SECTION 00 91 03

ADDENDUM NO. 3

This document includes requirements that clarify or supersede portions of the Request for Proposal. This Addendum is a Contract Document.

Markerboard
(Flat style)

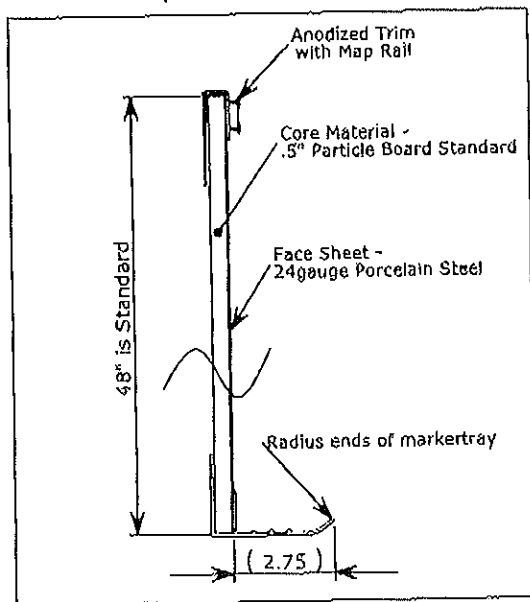
3.	Section 10 11 00	Visual Display Boards: Newline Products, Inc. of Plano, TX is deemed an acceptable manufacturer subject to the conditions described in the Substitution Request Response Form attached herewith. Product information is also attached.

1. Newline specification accompanying substitution request not accepted – abide by the project specifications in section 10 11 00.
2. Provide Markerboard (Flat Style) as shown in sheet 1 of 1 in substitution request, as the profile of the markertray matches that of detail 23/A10.51.

13 **PROJECTOR WALL MOUNT** 1'-1/2" = 1'-0"

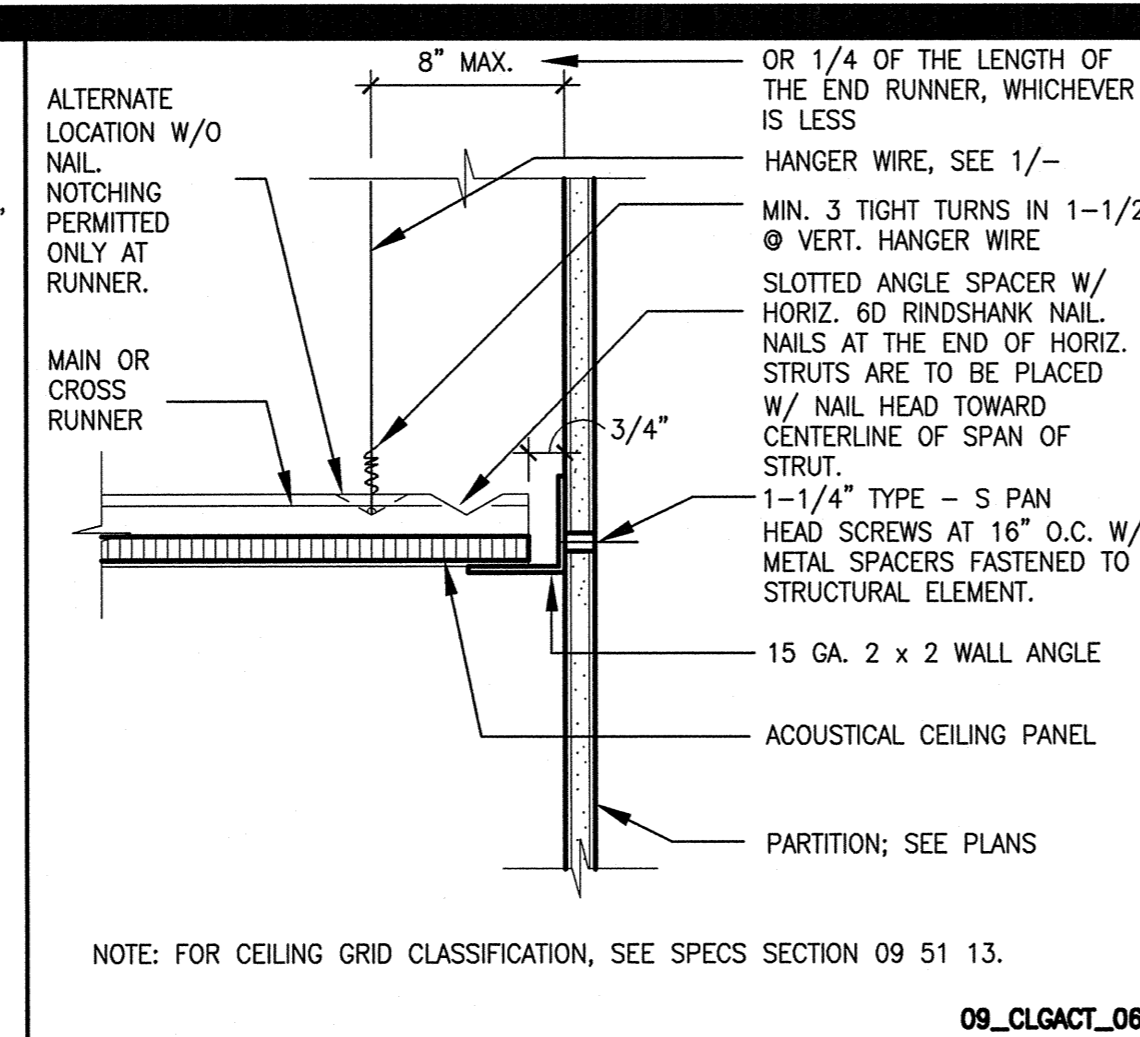
Item No.	Reference	Description
6.	Sheet A10.91	Suspended Acoustical Ceiling Details: Add detail 13 – Projector Wall Mount, as shown on attached revised Drawing A10.91.

13. Note 85 on sheet A3.12 refers to detail 13 on sheet A10.91 for the wall mounted projector bracket. However sheet A10.91 has no detail 13. Please provide detail 13/A10.91 for the wall mounted projector bracket.

Response: See revised sheet A10.91 for detail 13: projector wall mount (included in this Addendum 3). See also revised specification section 11 52 16 Projector Mounts for projector wall mount information.

1 SITE PLAN - ELECTRICAL
SCALE: 1/16"=1'-0"

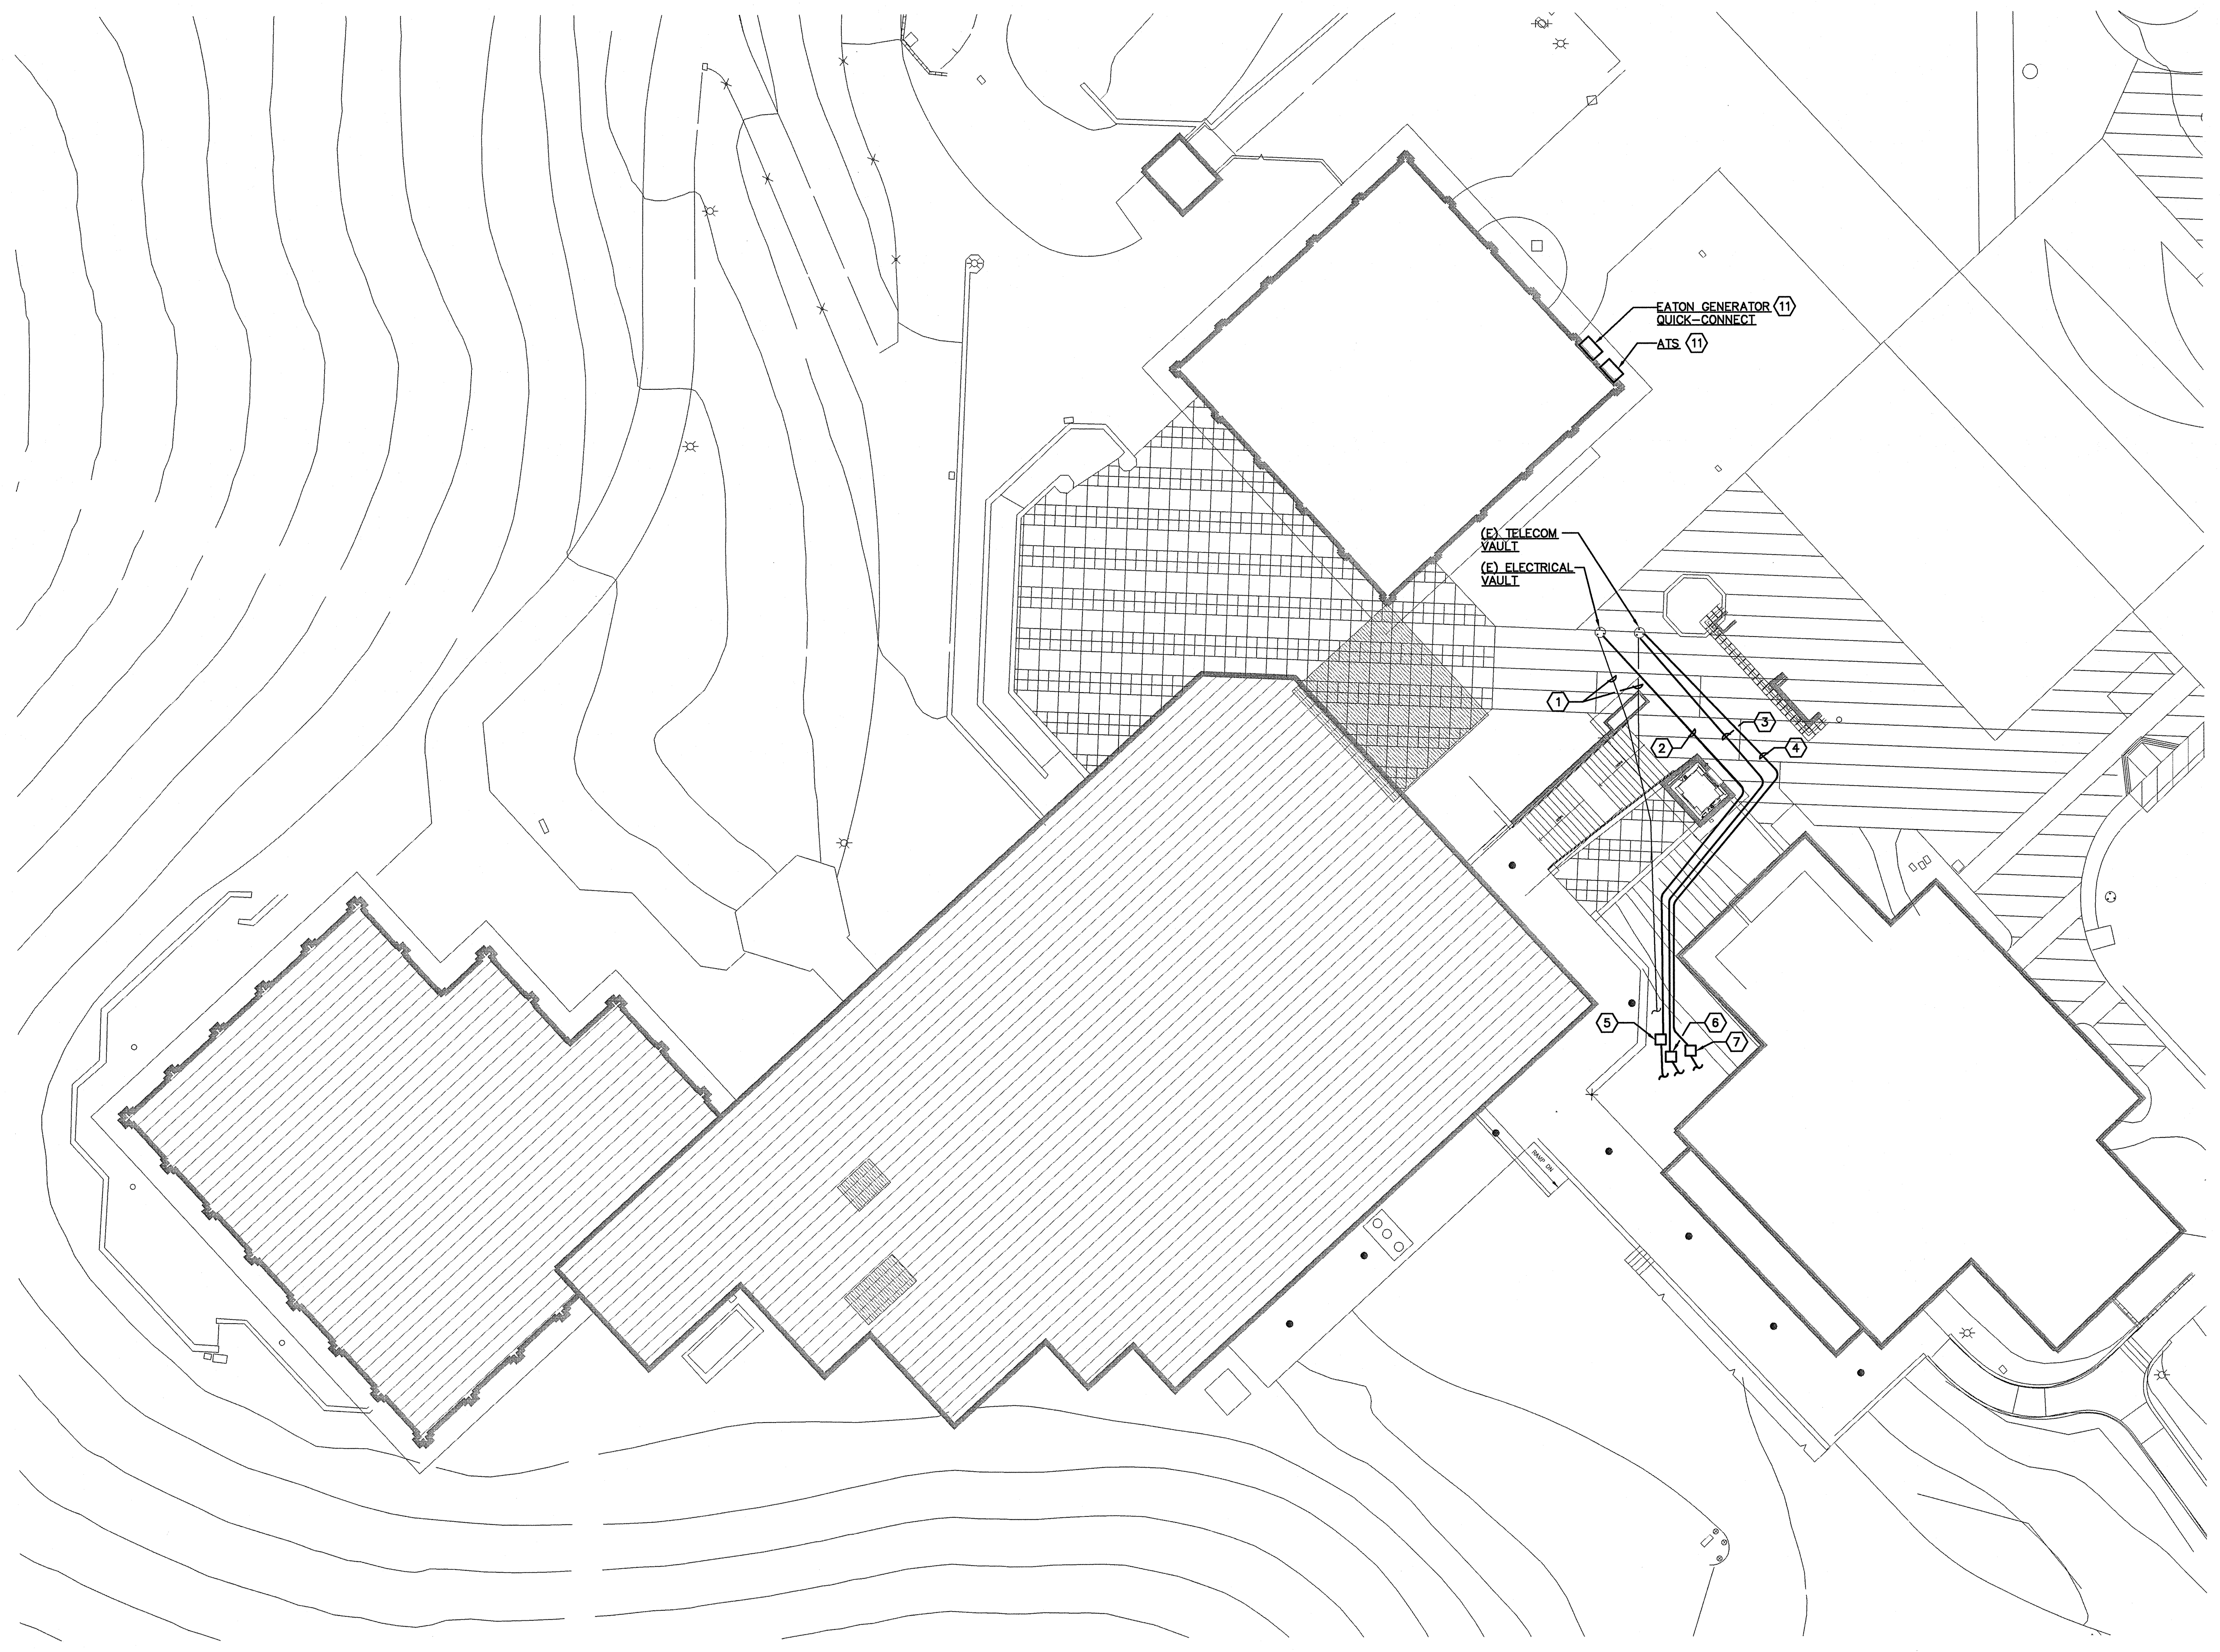
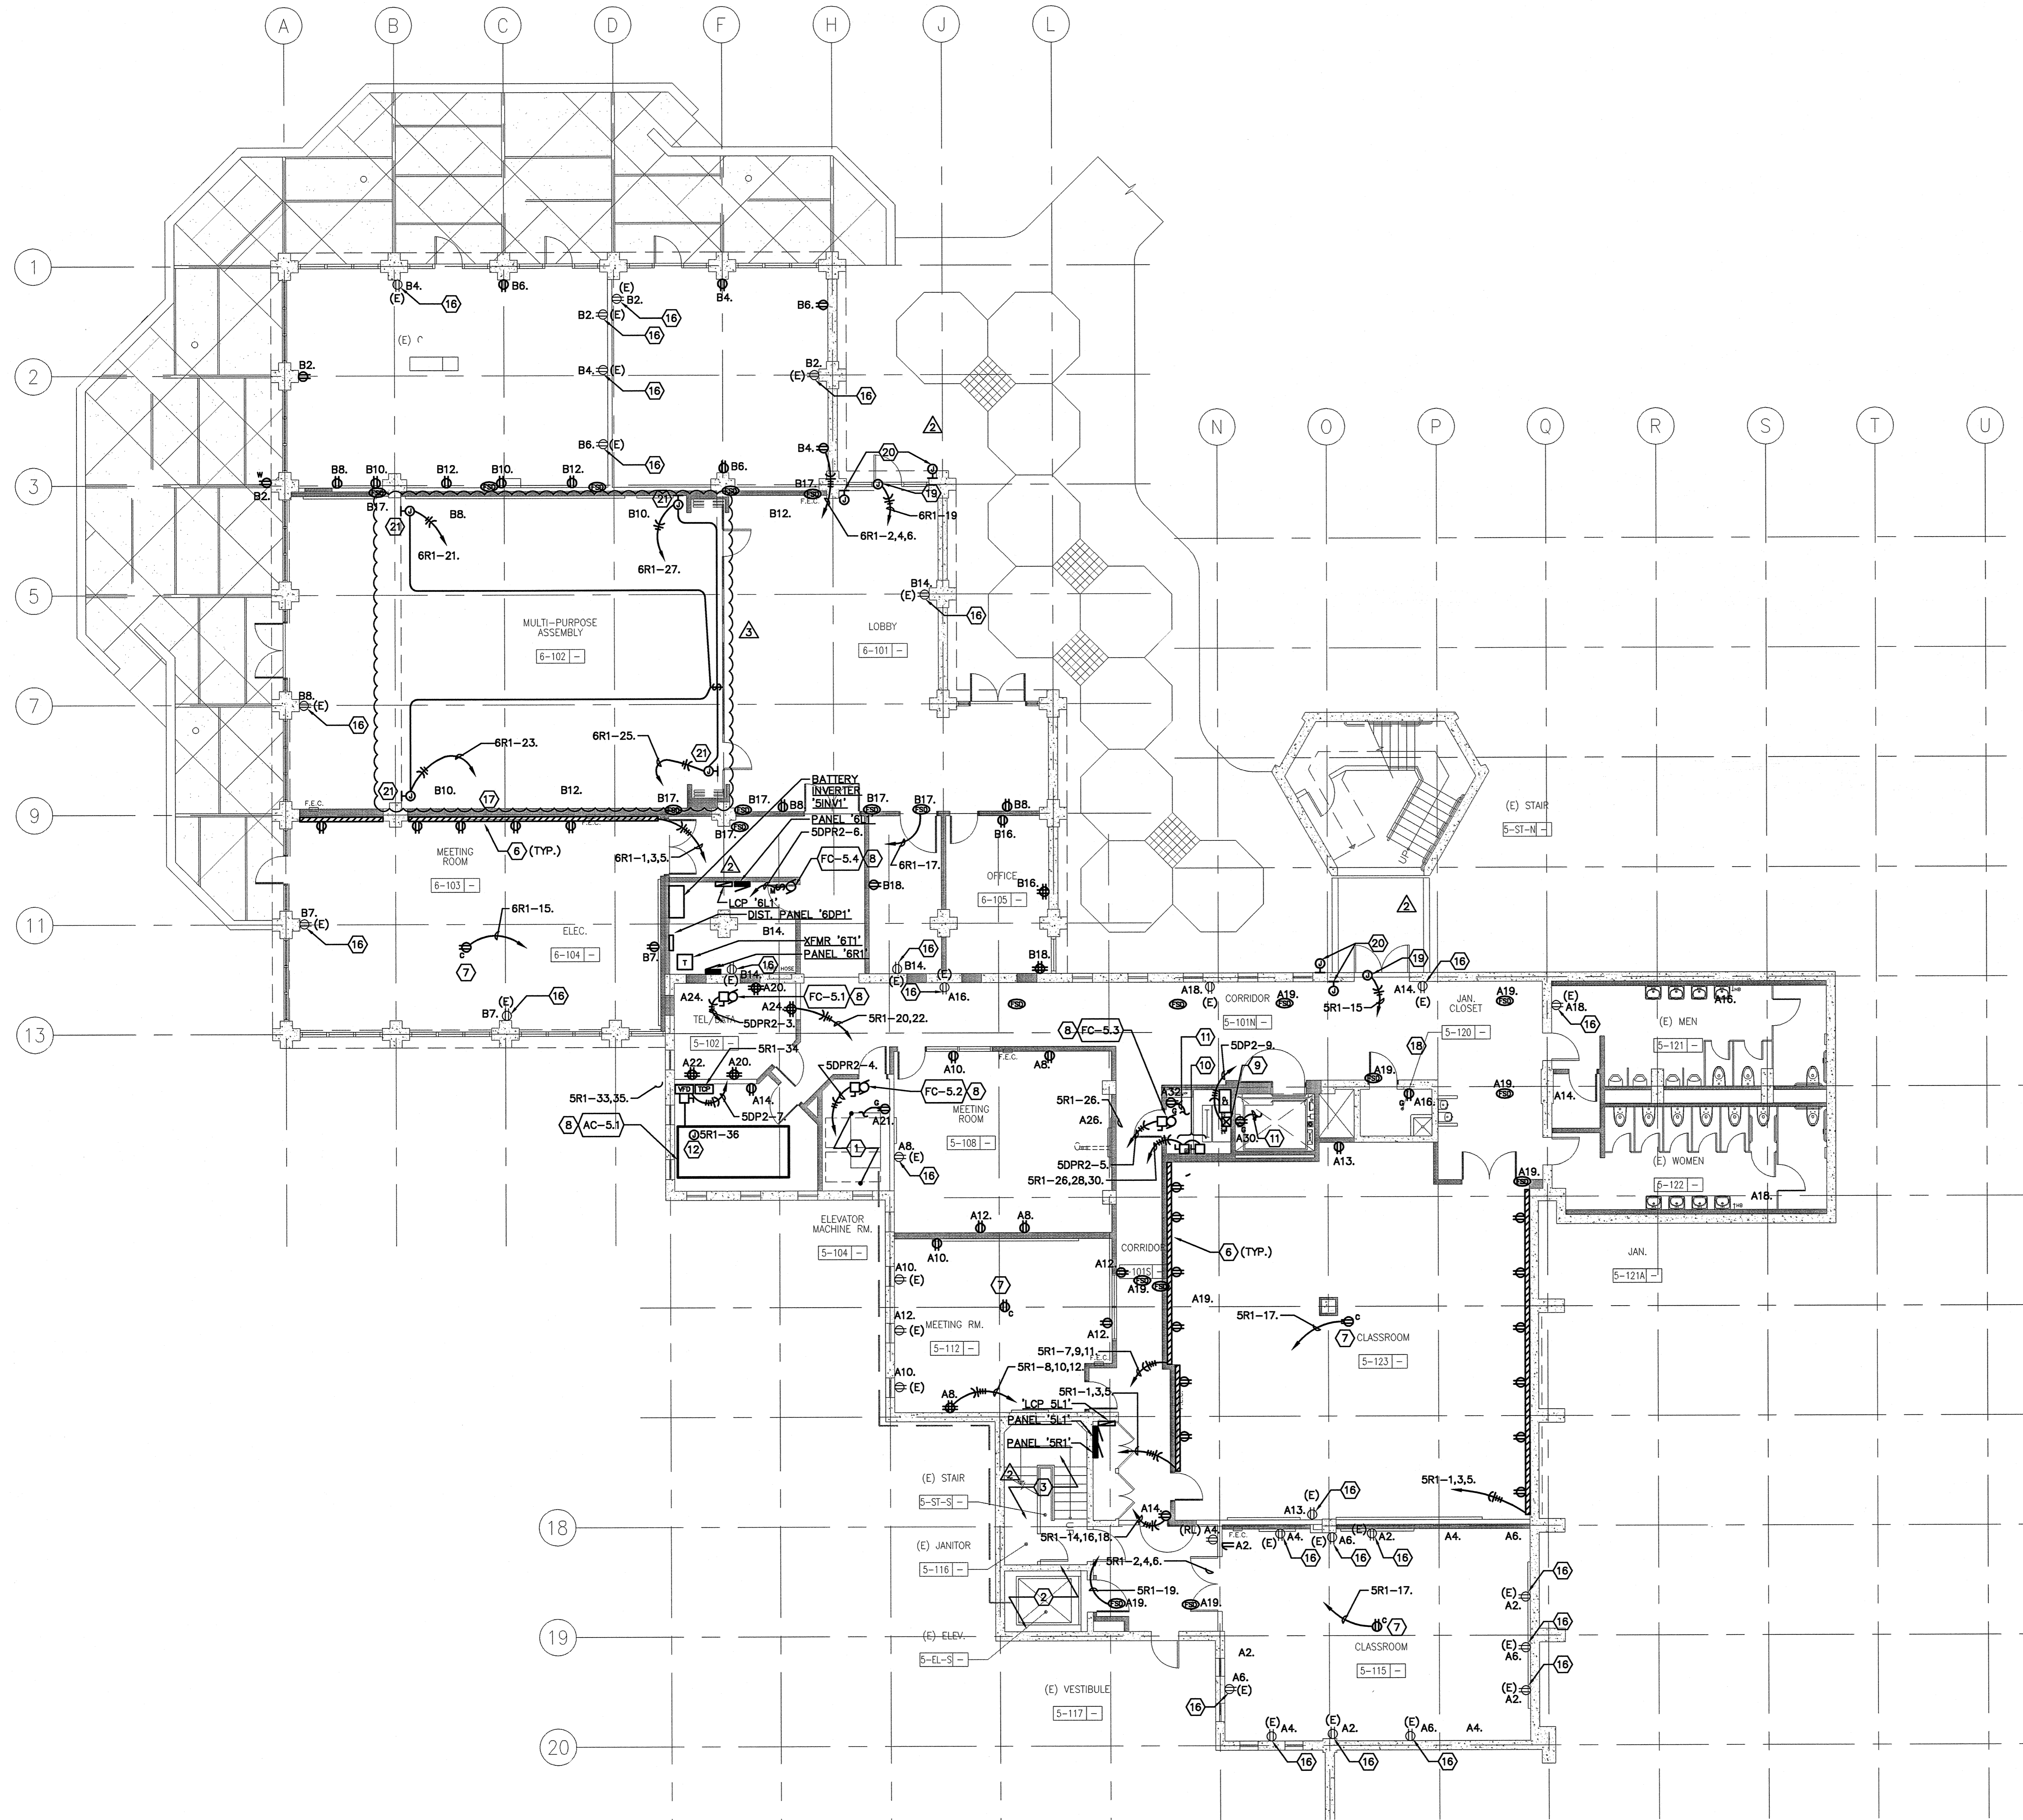
7.	Sheet M4.1	Mechanical Equipment Schedules: Modify the Air Handling Unit Schedule, as shown on attached revised Drawing M4.1.
8.	Sheet E1.1	Site Plan Electrical: (Reference Addendum No. 2, Item 59) A. Modify Sheet Keynotes 9 and 10, as shown on attached revised Drawing E1.1. B. Modify Detail 2 to indicate additional information for the generator and automatic transfer switch, as shown on attached revised Drawing E1.1.

46. On E1.1, Site Plan Electrical, a new 230A 480V N3R ATS is shown. Please provide a specification for ATS.

47. On E1.1, Site Plan Electrical, a "Eaton Generator Quick Connect" terminal box is shown. Please provide specification for Eaton Generator Quick Connect.

Response: Required information for bidding equipment is shown on drawings. Refer to revised sheet E1.1 for Addendum 3.

Response: Required information for bidding equipment is shown on drawings. Refer to revised sheet E1.1 for Addendum 3.
